From: "Bob Bailey" <bobbailey@bayerbecker.com>
To: "Teresa Barnes" <BarnesT@bceo.org>
Date: 10/27/05 8:36AM
Subject: Chesterwood Drainage[Scanned]

Drawing:	05F077DR
Scale	1" = 100'
Drawn by:	JLR
Checked By:	RWB
Issue Date:	10/24/05

CHESTERWOOD DRAINAGE ROUTE

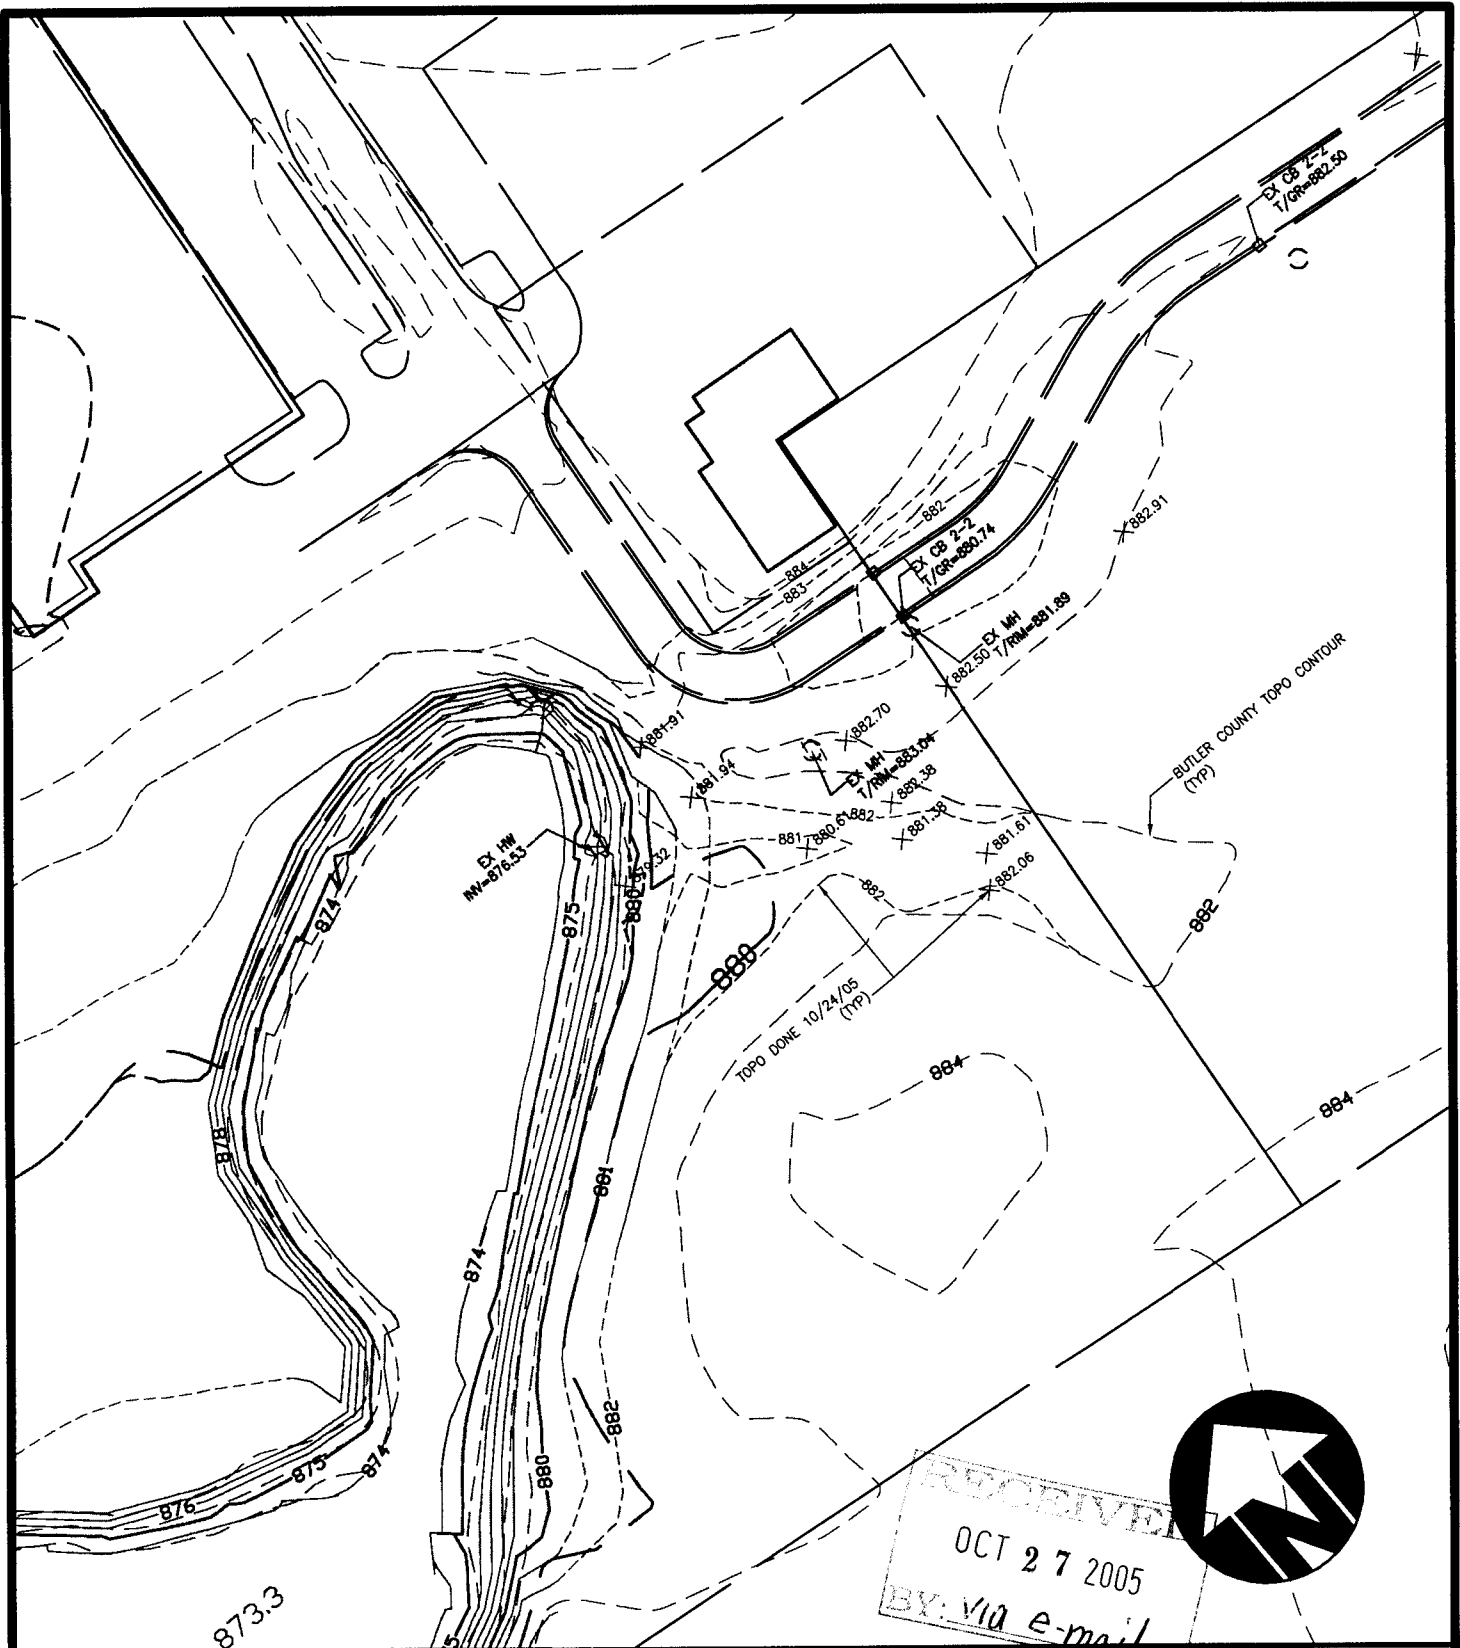
Attached is a pdf file of the drainage at the Chesterwood west retention basin. This is in response to your comments about verification that the flood route from the east basin is going down the street to a low point and then into the west basin. Based on the fieldwork that we got in the area and the Butler County topo outside that area, it does appear that the water will enter the west basin. The Butler County topo appears to be in close agreement with the topo that we did. There is a swale south of the street and catch basins which does drain toward the west basin.
